**Addendum No. 1**  
**City of Coquitlam**  
**RFP 25-077**  
**Removal of Preload from Cedar Drive**  
 (Consists of 3 Pages)

Issue Date: July 11, 2025

**Questions & Clarifications**

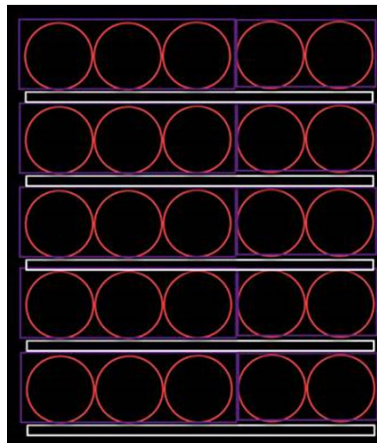
Q8) For Pay Item #5.01, how are the bundles of pipes expected to be delivered to the site?

**A8) A total of 32 pipes (pipe length 50 feet) will be delivered. The pipes will be in bundles, in sets of 2 and 3. See illustration below. The white represents wood that will be placed between each row, and the purple represents the bundling and how many will be in each.**
